# Backfeed v263

## 145.2.4 PSE PI

**Figure 145-27a — Detection signature requirements connection configurations**

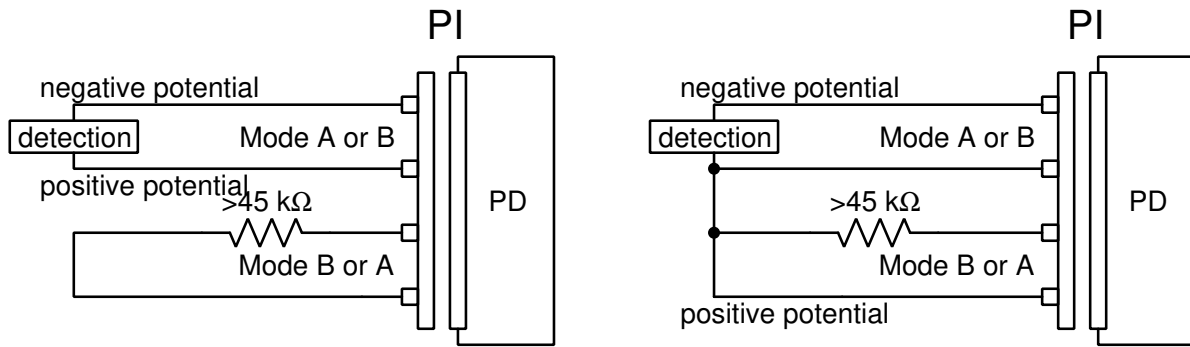
While a PD presents a valid detection signature on a given Mode, that detection signature shall be valid when presented under the following conditions (see Figure 145-27a):

- with a resistance greater than 45 k $\Omega$  across the other Mode
- with a resistance greater than 45 k $\Omega$  across the other Mode and one pair connected to the positive potential of the given Mode

**Add new Figure 145–27a as follows:**

**Figure 145–29a — Reflected voltage requirements**

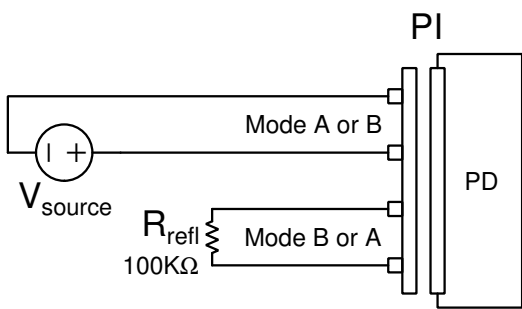
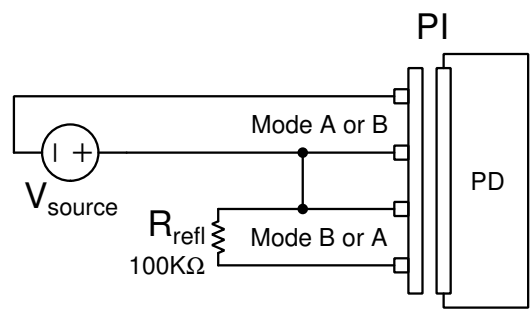
**Replace the contents of 145.3.8.8 as follows:**

For a single-signature PD, when any voltage in the range of 0 V to  $V_{Port\_PD-2P\ max}$  is applied per any of the valid 2-pair configurations, defined in Table 145-20, that have only a single pair connected to positive  $V_{PSE}$  (see Figure 145-29a), the voltage on the Mode not connected to the voltage source, with a 100 k $\Omega$  resistor connected across that Mode, shall not exceed  $V_{refl}$  as defined in Table 145-29.

For a dual-signature PD, when any voltage in the range of 0 V to  $V_{Port\_PD-2P\ max}$  is applied per any of the valid 2-pair configurations, defined in Table 145-20, including those with two pairs connected to positive  $V_{PSE}$  (see Figure 145-29a), the voltage on the Mode with at least one pair not connected to the voltage source, with a 100 k $\Omega$  resistor connected across that Mode, shall not exceed  $V_{refl}$  as defined in Table 145-29.
